LIME DOWN SOLAR PROJECT

DEADLINE 4 COMMENTS STOP LIME DOWN

July 2026

Lime Down: Daily Generated HGV and LV Movements (Revised Calcs)

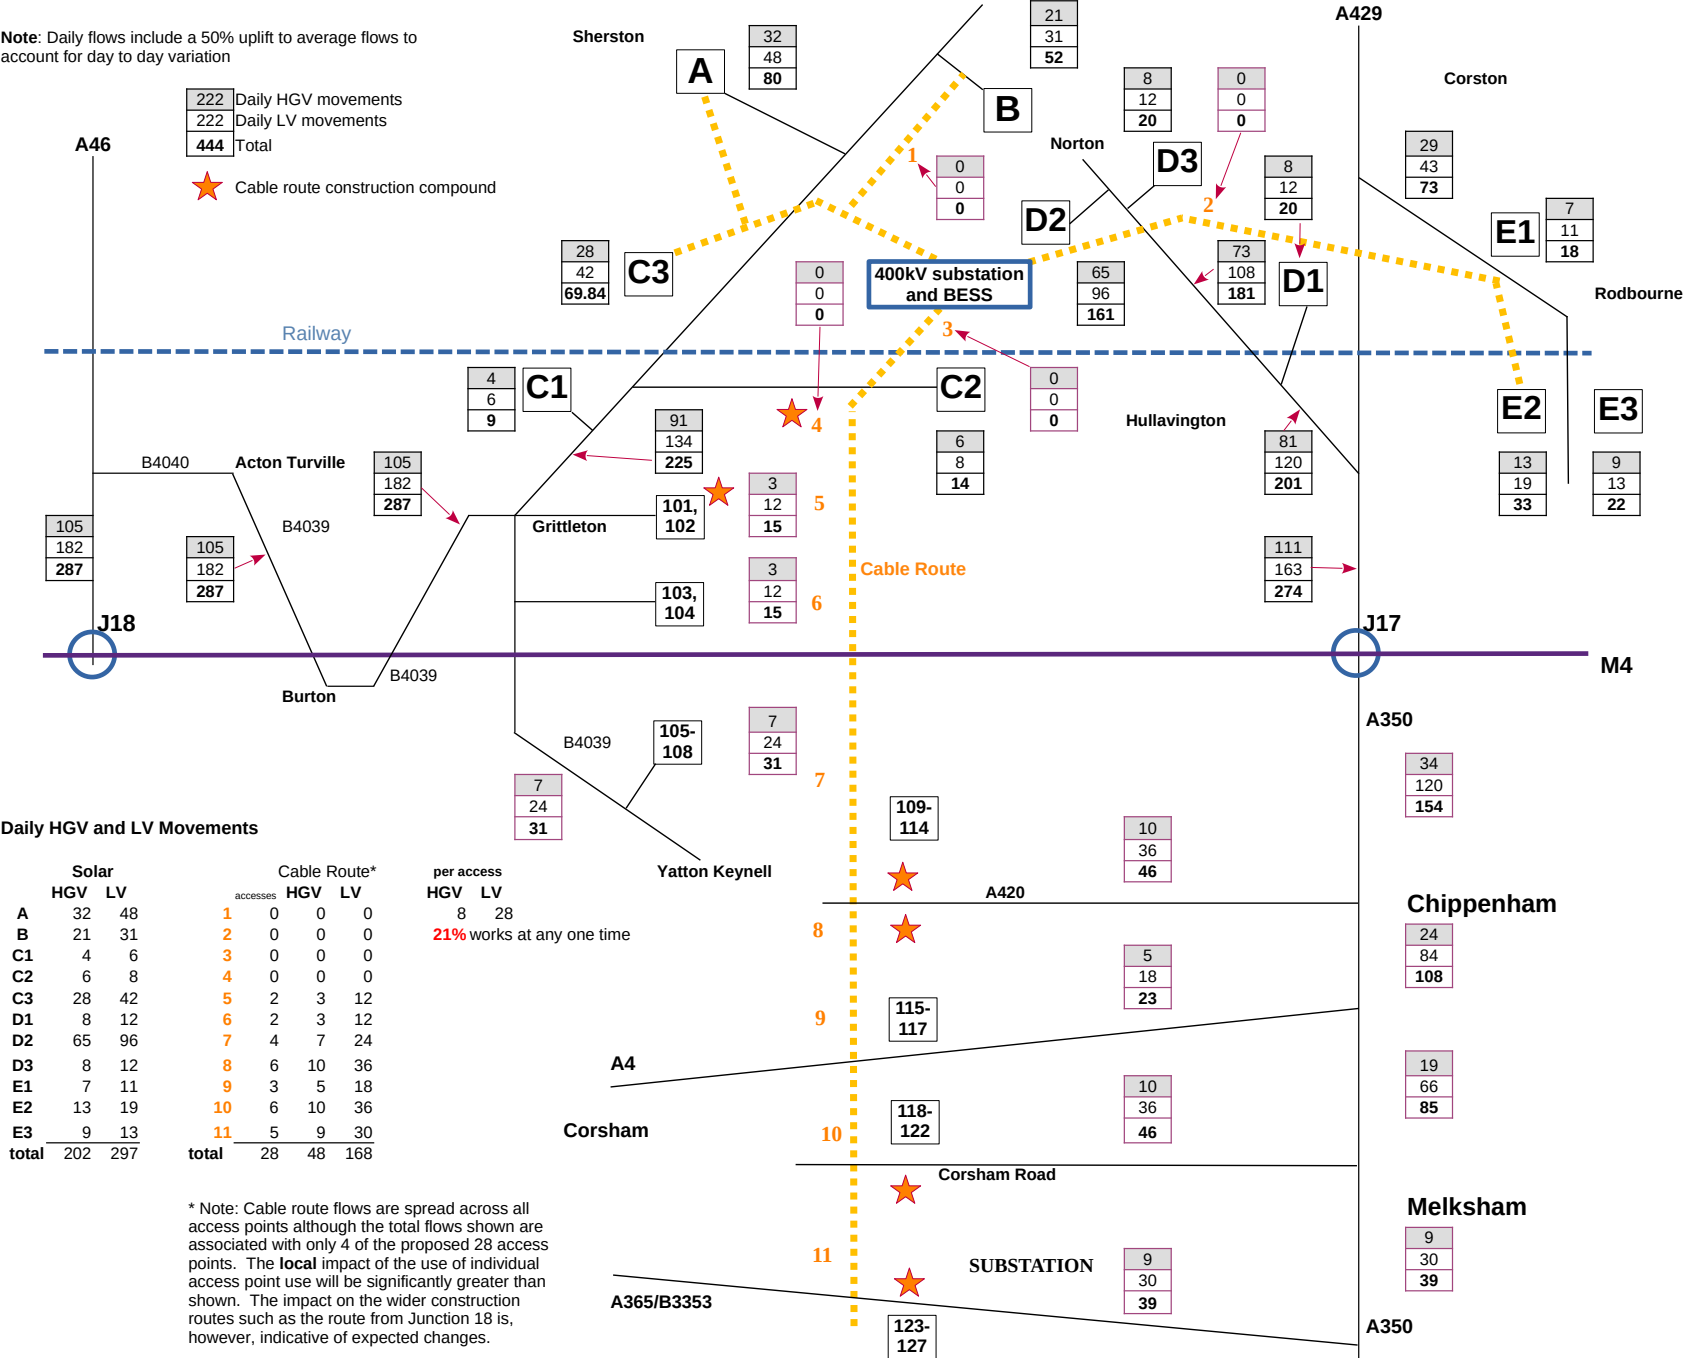
Number of accesses	28						
Days operating	90						
Total HGVs	10,080	4 per access per day					Total HGV movements including cable route
Total HGV movements	20,160					67,661	
Average HGV movements on a single day	32	4 accesses open at any one time					
With 50% uplift to represent day to day variation	48						
Total LGVs	10,080	4 per access per day					
Total HGV movements	20,160						
Average HGV movements on a single day	32	4 accesses open at any one time					
With 50% uplift to represent day to day variation	48						
cable route staff per access point	10						
car trips per day per access point	20	100.0% single occupancy car driver mode share					
total car trips	50,400						
Average total car trips on single	80						
With 50% uplift to represent day to day variation	120						
Total light vehicle movements	70,560						
Total daily LGVs and cars (50% uplift)	168
